Joseph M. Farley Nuclear Plant
Technical Specifications Revision
Spent Fuel Cask Loading Requirements

Joseph M. Farley Nuclear Plant Technical Specifications Revision Spent Fuel Cask Loading Requirements

Marked-up Technical Specifications and Corresponding Bases Pages

Figure 3.7.18-1 Fuel Assembly Burnup Limit Requirements for Cask Storage

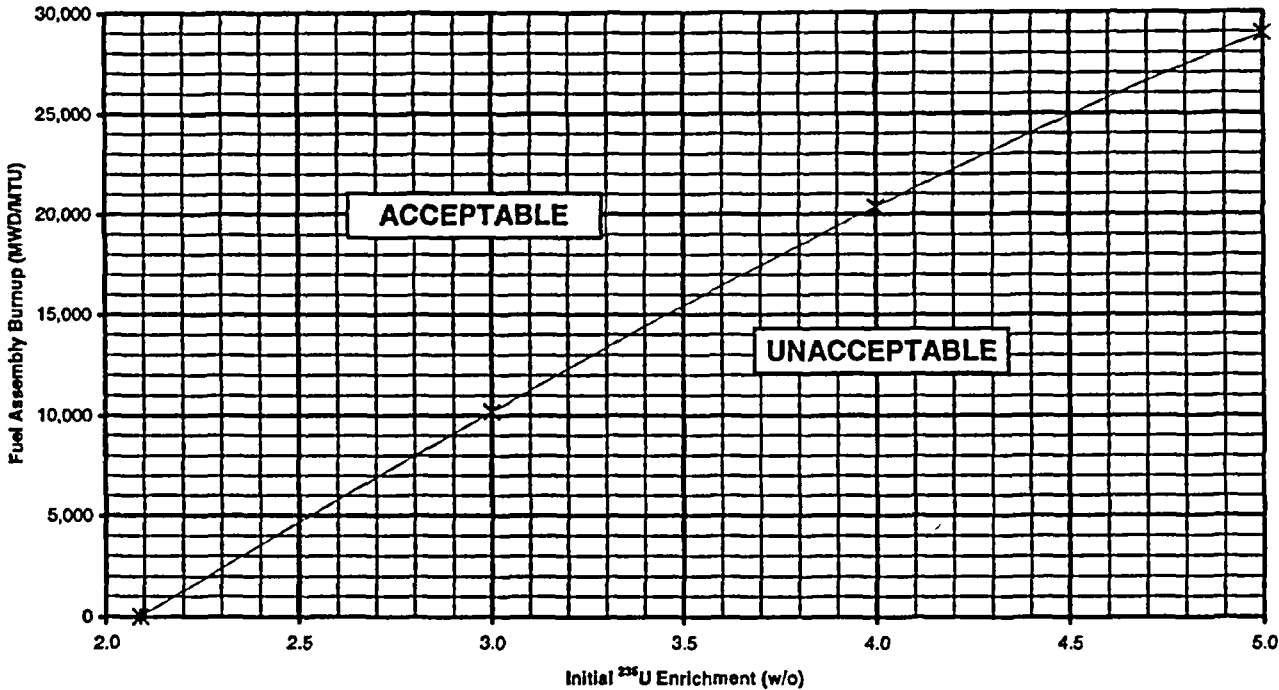
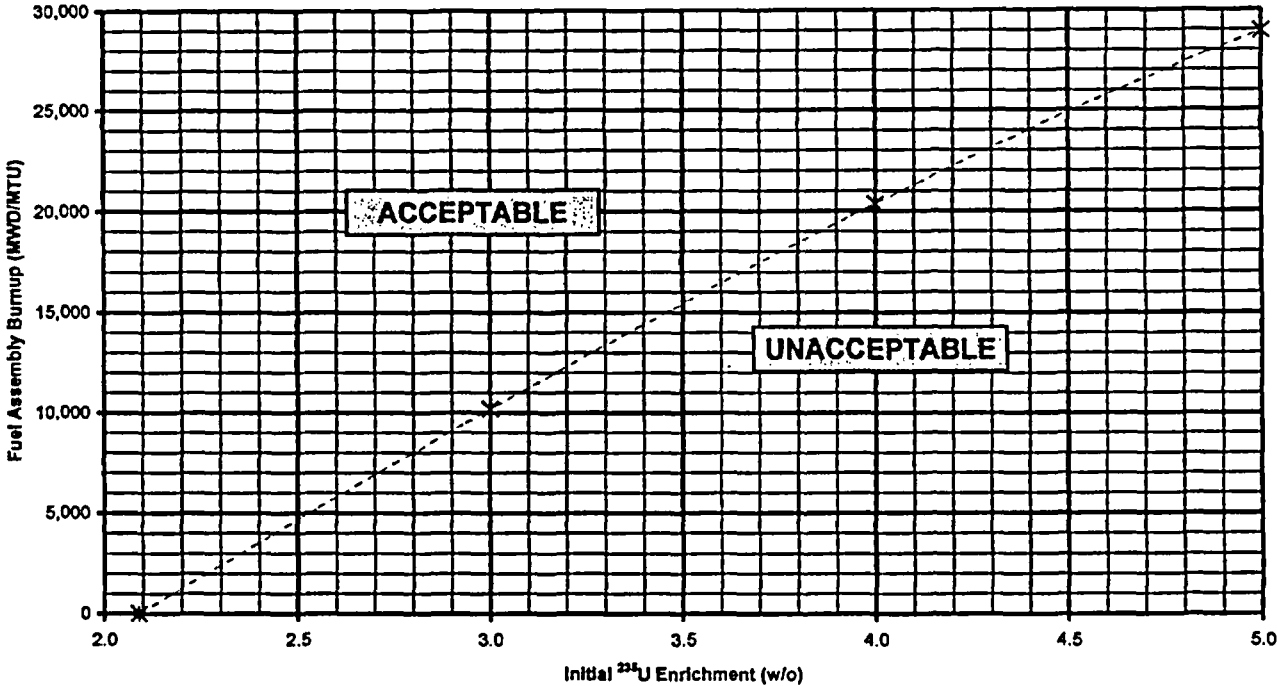
LCO 3.7.18 The combination of initial enrichment and burnup of each spent fuel assembly stored in the cask storage area shall be within the Acceptable Burnup Domain of Figure 3.7.18-1.

The above methodology was used to evaluate cask loading of Westinghouse 17X17 fuel assemblies with initial enrichments less than or equal to 5.0 weight percent U-235 in the spent fuel cask during loading operations in the cask storage area. The resulting enrichment and burnup limits are shown in Figure 3.7.18-1.

Westinghouse 17X17 fuel assemblies with nominal enrichments less than or equal to 5.0 weight percent U-235 can be stored in the spent fuel cask. The fuel assemblies must satisfy the minimum burnup requirement as shown in Figure 3.7.18-1.
